RECEIPT DATE: 1/3/18 **ONSITE SEWAGE DISPOSAL SYSTEM** P 562382

PROPERTY ADDRESS: 15040 Double Bridges Court

SEPTIC PLAN
MERIWETHER FARM
SECTION ONE LOT 2

15040 DOUBLE BRIDGES COURT
TAX MAP NO.: 21 PARCEL NO.: 24 GRID NO.: 21
ZONED: RC-DEO PLAT NO.: 21342
FOURTH ELECTION DISTRICT HOWARD COUNTY, MARYLAND
SCALE: 1" = 30' DATE: JANUARY 2018
SHEET 1 OF 1

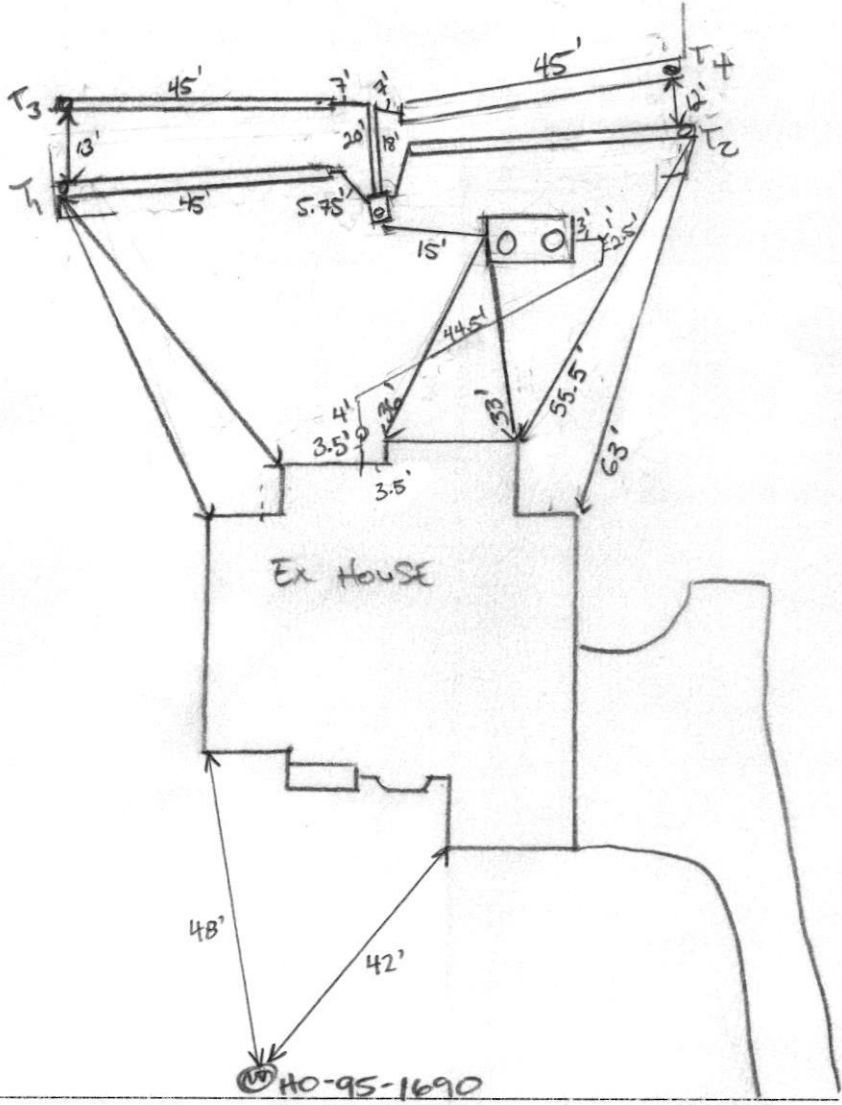
4/10/18 Contour shot in field. Same as approved O&S plan. Sewer have not as per plan. coming out on opp side of house. Plenty of fill should be ok. S.T. to come up will give 2' or 3'. Call for map (KWD)

4/10/18 (pm) Tank Set. @ 4/11/2018 High trenches dug, T1 complete, ok to backfill to continue const. T2 needs more stone. 4/12/18 T2 + T4 complete. Trenches connected to D Box. D Box leveled. @ 4/13/2018 SHC + Sewer line installed from house to ST. Reinspect for inlet baffle extend 1/8" below invert. Currently extends 6.5" below invert. @ 10/16/18 site visit made by S. Collins to confirm baffle extension. could not open lid on tank. phone call made to contractor.

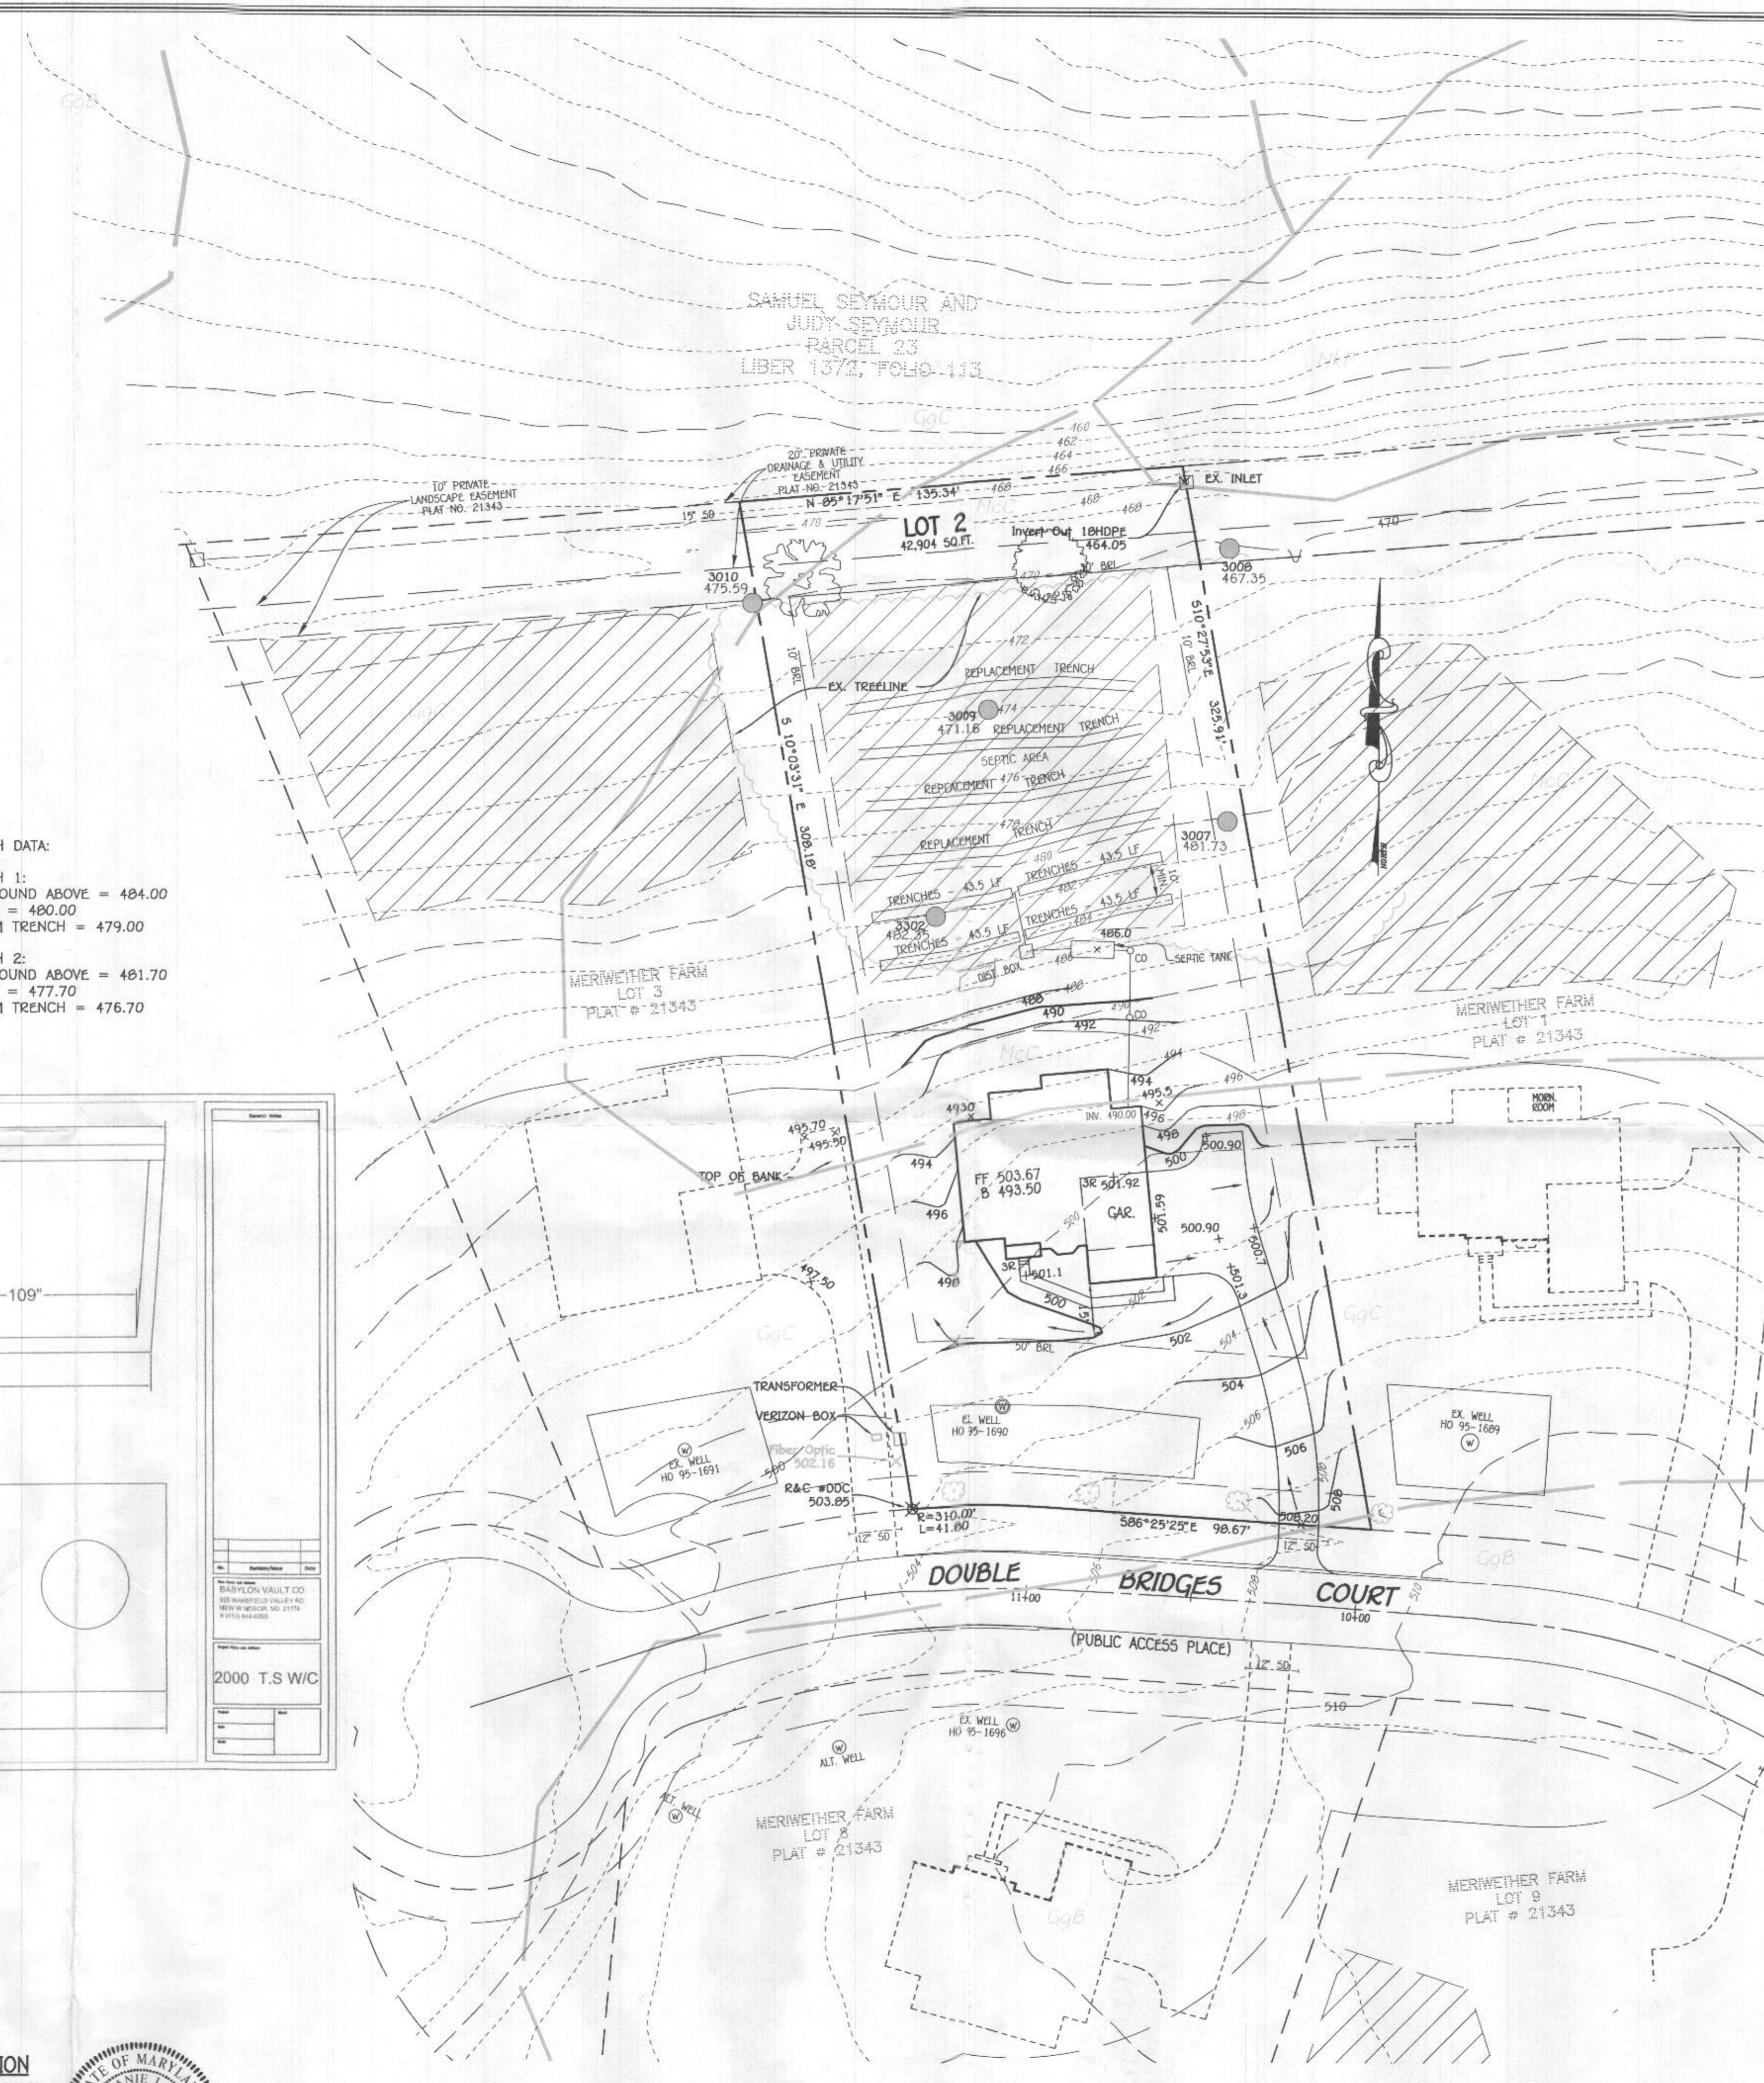
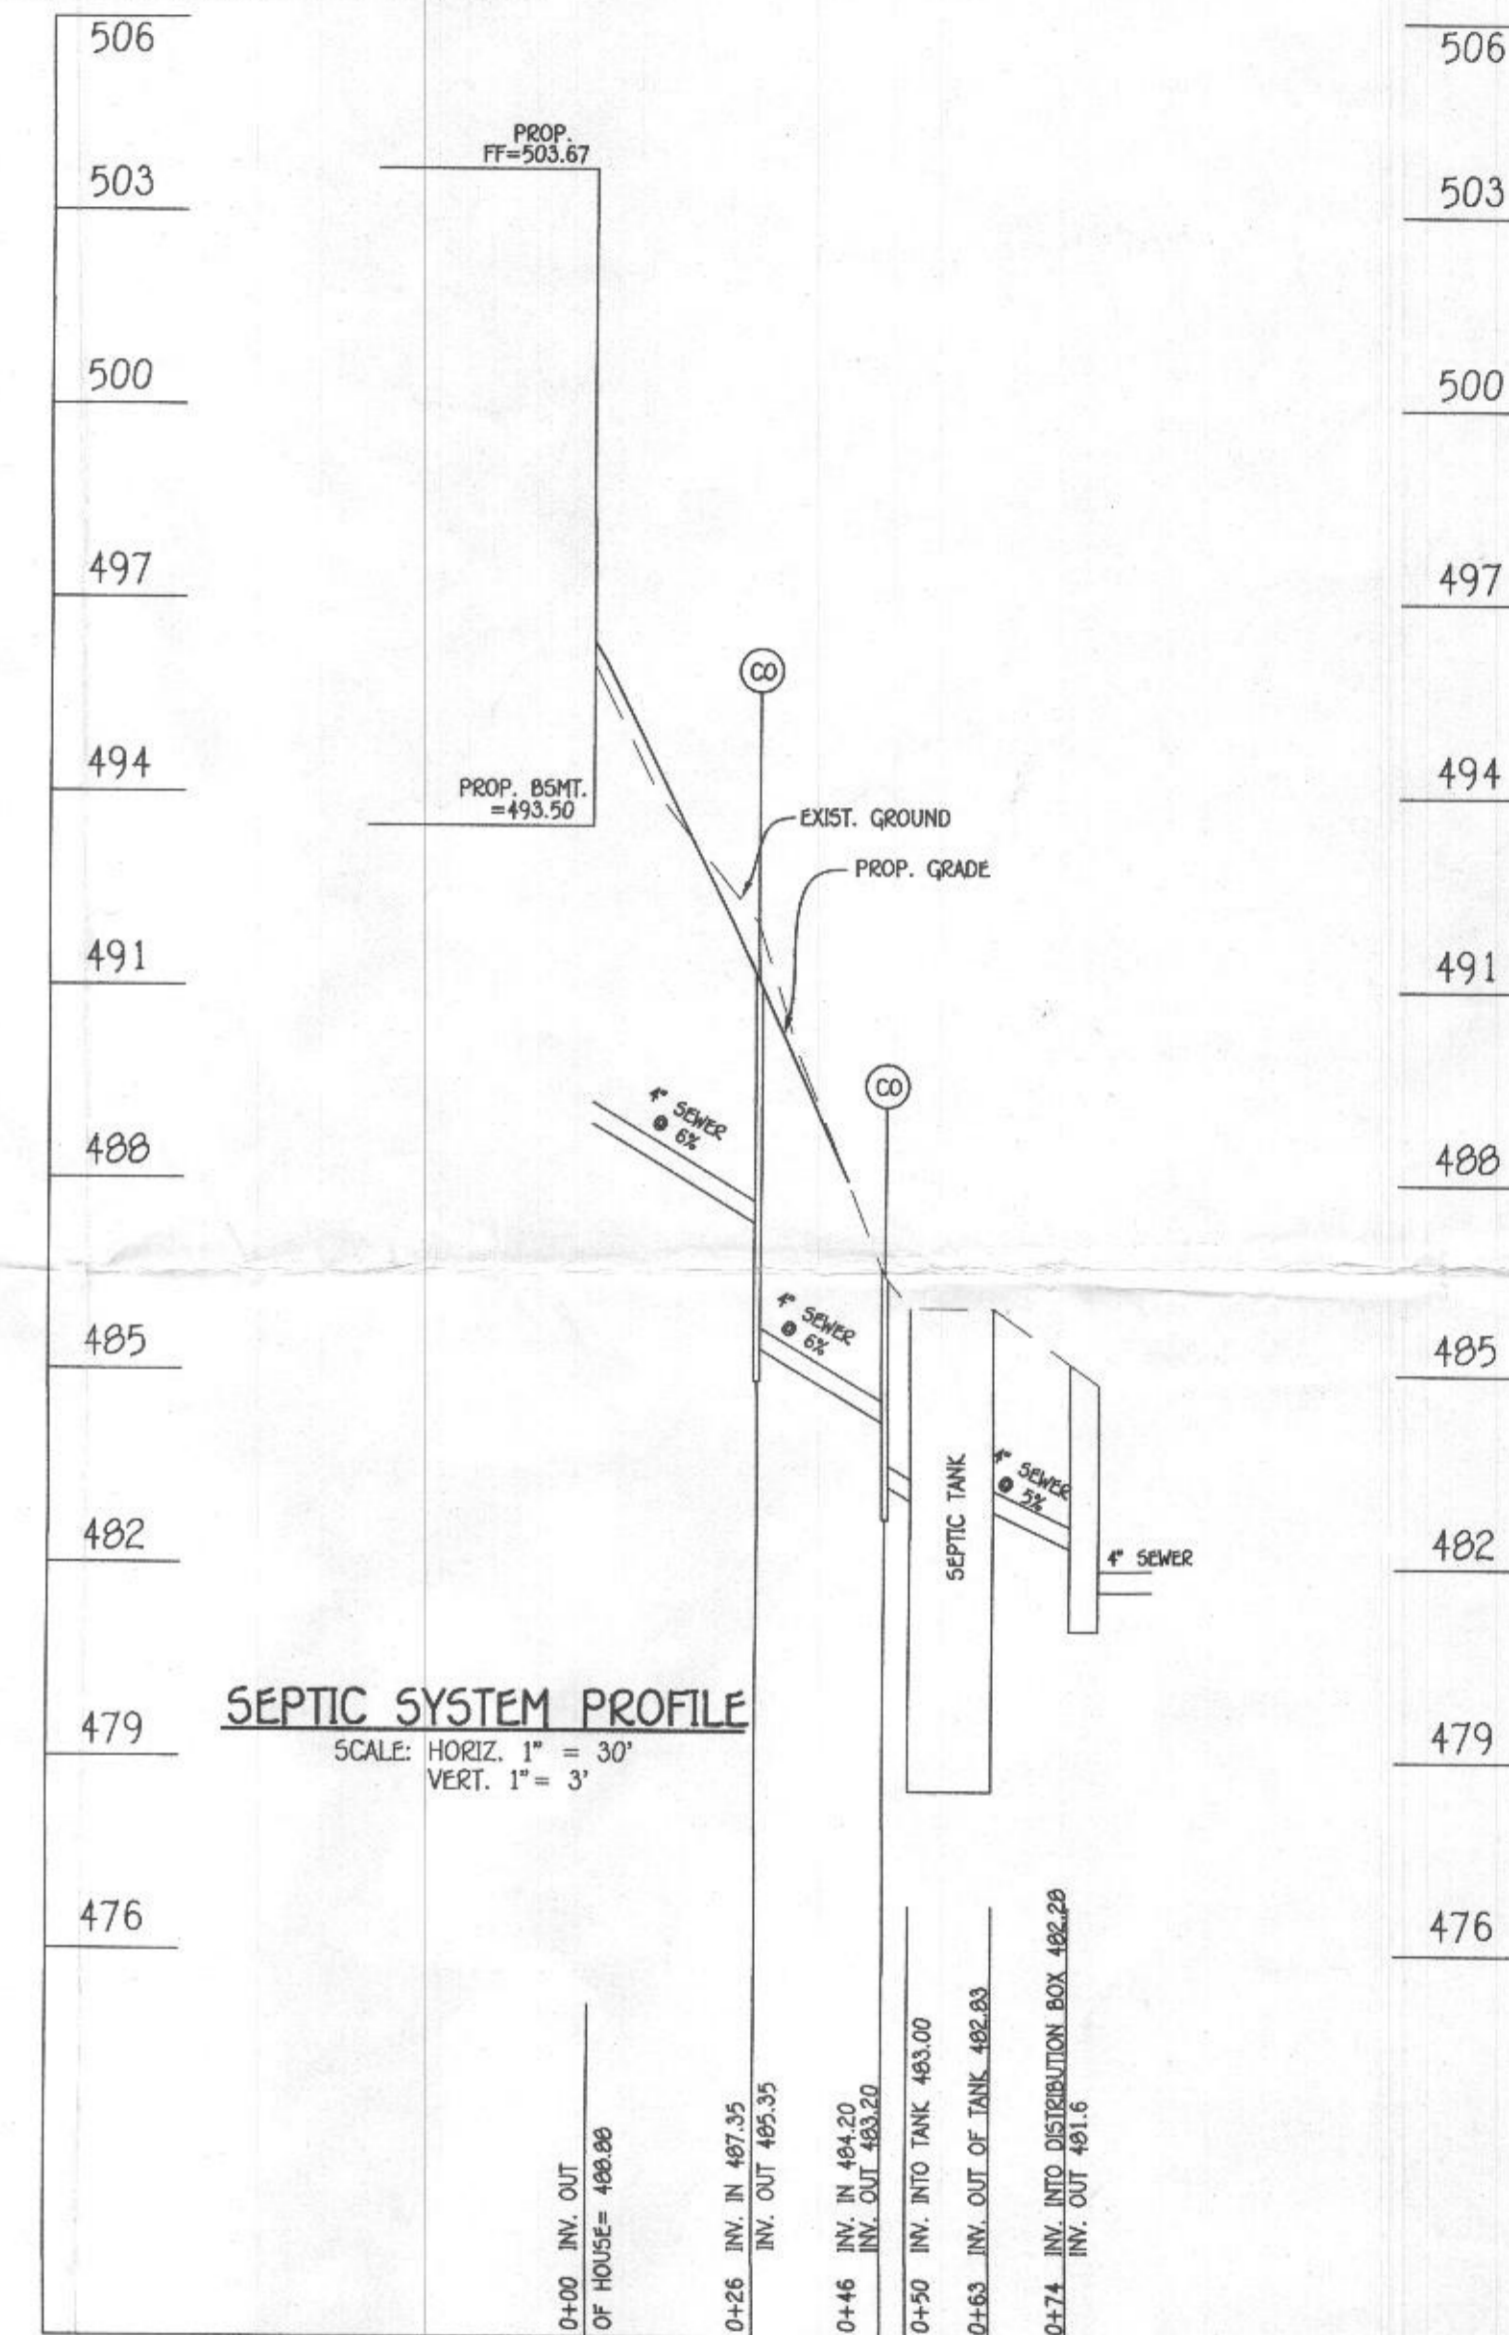
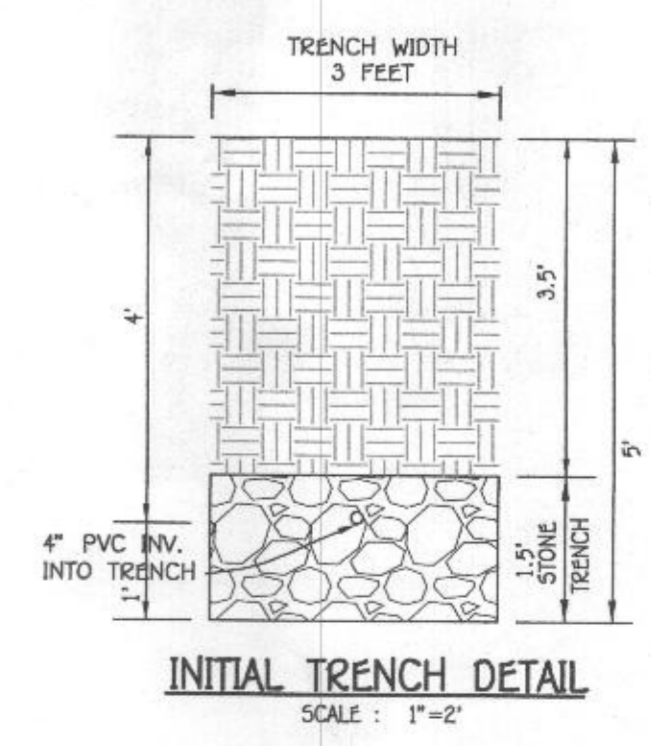
- 1.) Add required notes to plan (Please see attachment, pg. 2).
- 2.) Show separation between trenches.
- 3.) Label replacement trenches.
- 4.) Septic Profile % fall are labeled incorrectly and should be 14, 10 and 6 %. In addition, adjust last 5 feet of line to 2 – 5 %.

Good morning. Quick question about the OSDS Plan for 15040 Double Bridges Court. Are you proposing 2 – 87s or 4 - 43.5s trenches for each system? If its 2 trenches, then the d –box should be moved to the end of the initial trench like it was designed in 2014. If its 4 trenches then show separation between trenches.

The trench calculations were not done according to the proper specs. Please see the attached spec sheet. The trench max bottom depth is 5' with an effective area starting at 4' for a 1' sidewall credit.

Also, if the d-box is to go in the center of the easement, the trenches would go out on both sides from there, with shorter trenches extending in both directions towards the edges of the area.

The slope of the line from the house to tank and tank to d-box is too steep. If the slope is over 5%, you must show details of the line shallowing out to 2% in the last 5 feet before the tank and d-box.

Last, if there are any wells, wellboxes, or septic areas on the neighboring lots within 100' of the property line, they must be shown on the plan.
